To: T10 Technical Committee
From: Rob Elliott, HP (elliott@hp.com)
Date: 7 September 2006
Subject: 05-381r5 SAS-2 Multiplexing

Revision 5 (7 September 2006) Incorporated comments from 5 September 2005 multiplexing teleconference, including dropping START_LOGICAL_LINK and including an alternate multiplexing negotiation method based on SNW-3 (labeled **Option B**). Moved the IDENTIFY address frame REASON field to a separate proposal 06-409 since it is useful even without multiplexing.

Figure 3 — Phy class diagram

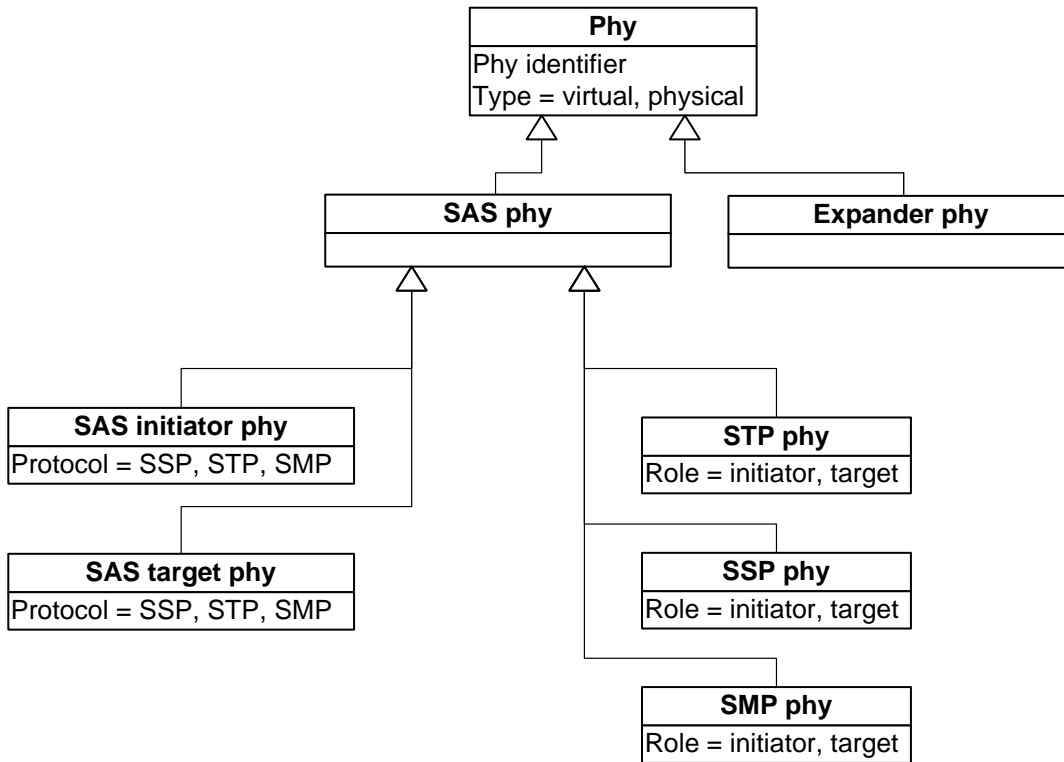
Editor's Note 1: Logical phys (SAS logical phys and expander logical phys) need to be included in the UML model.

Figure 8 — State machines for expander devices [\[updated to include logical phys\]](#)

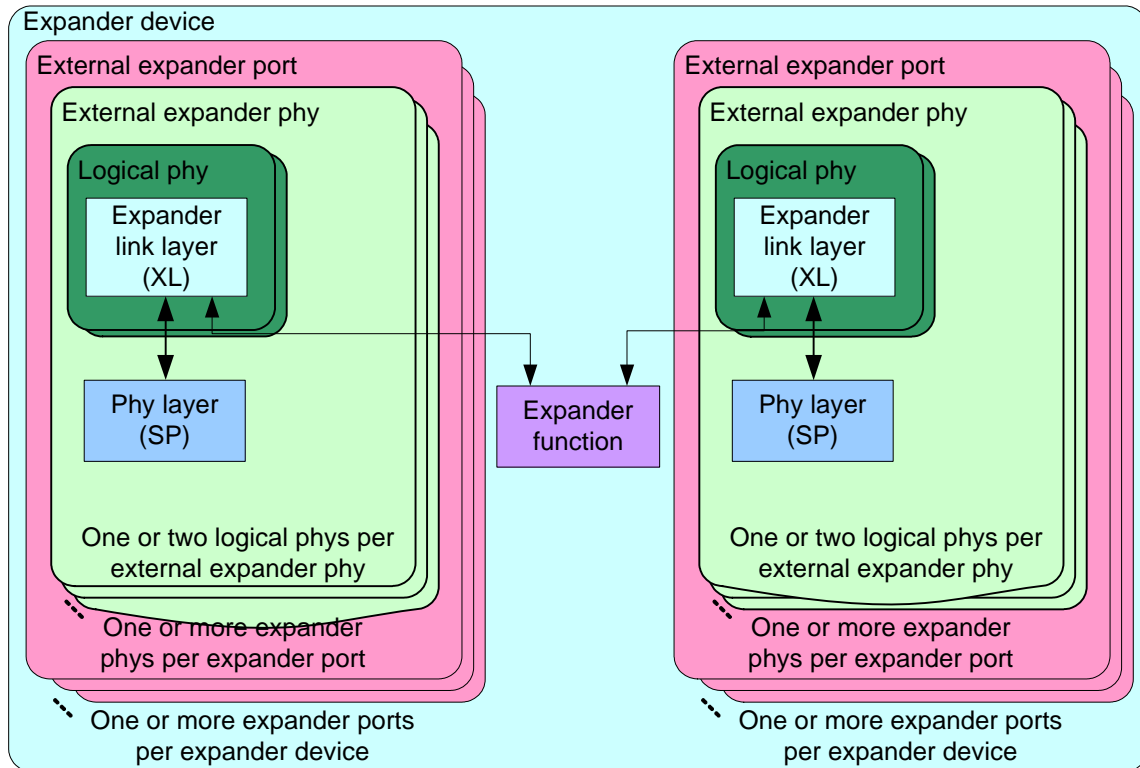
Editor's Note 2: Include SL_IR in the previous figure along side XL. It goes in the logical phy, because even in Option A SL_IRM is considered to be running in logical phy 0.

Figure 11 — Receive data path in a SAS phy [\[for Option A only: changed SL IR to SL IRM\]](#)

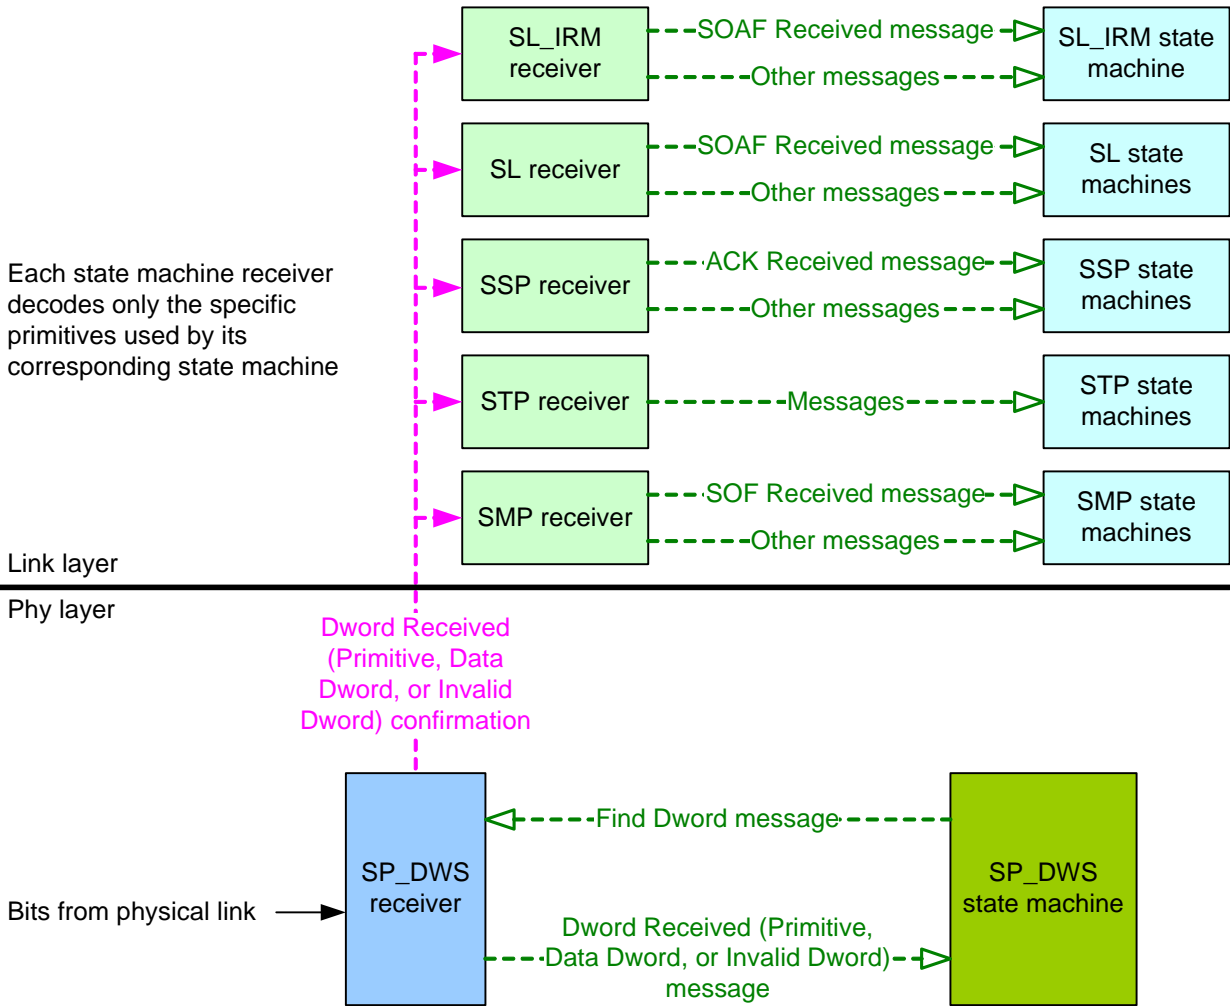
[Editor's Note 3: Option A: Change SL_IR to SL_IRM in the receive data path figures](#)

Figure 31 — Rate matching example [changed]

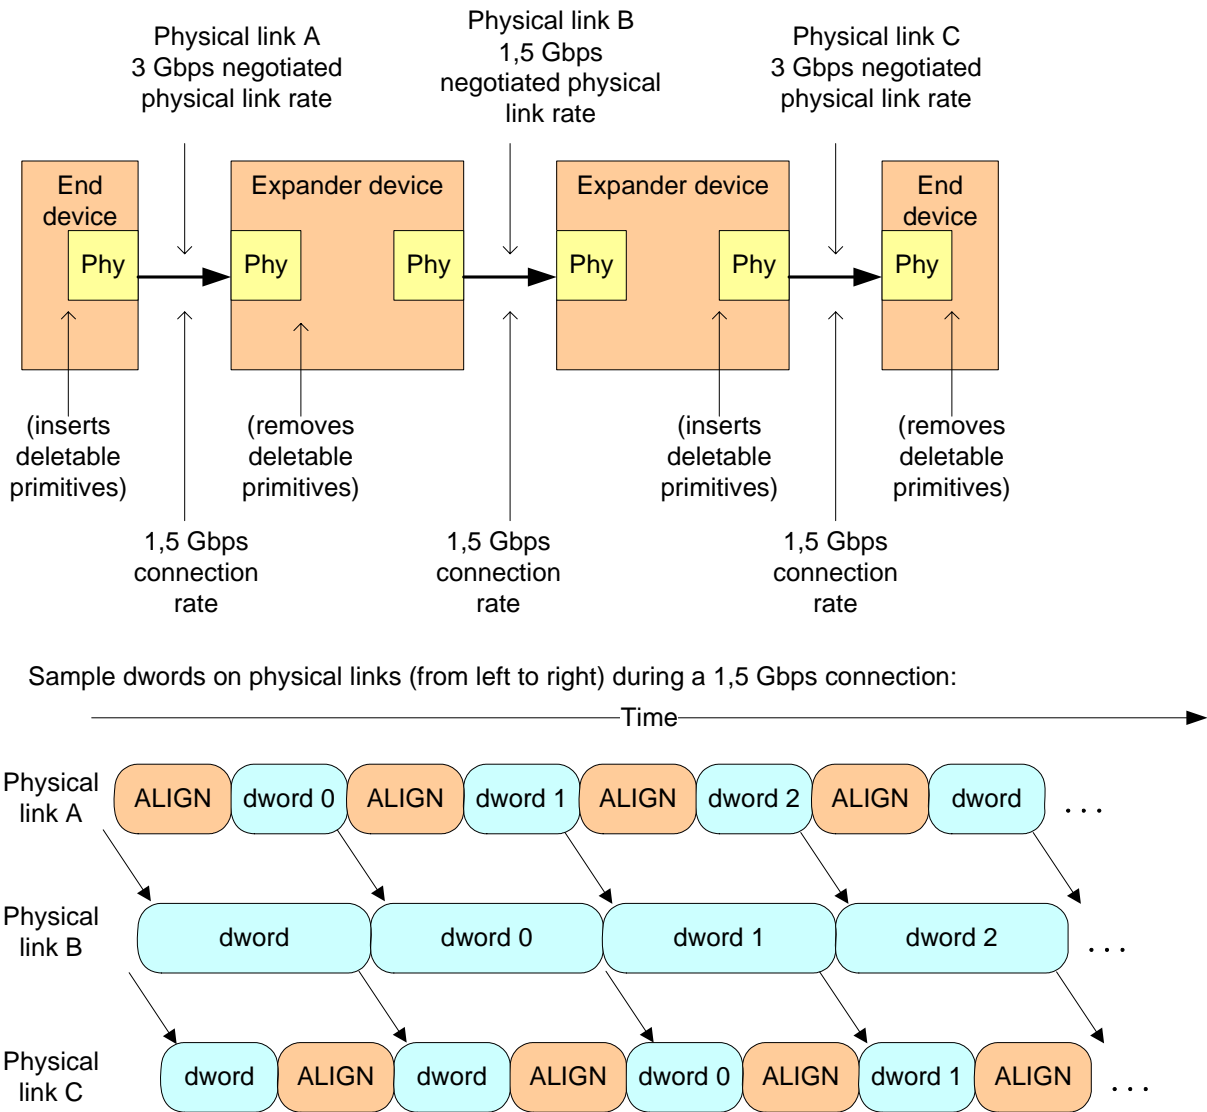
Figure 31 shows an example of rate matching between a 3,0 Gbps source phy and a 3,0 Gbps destination phy, with an intermediate 1,5 Gbps physical link in between them.
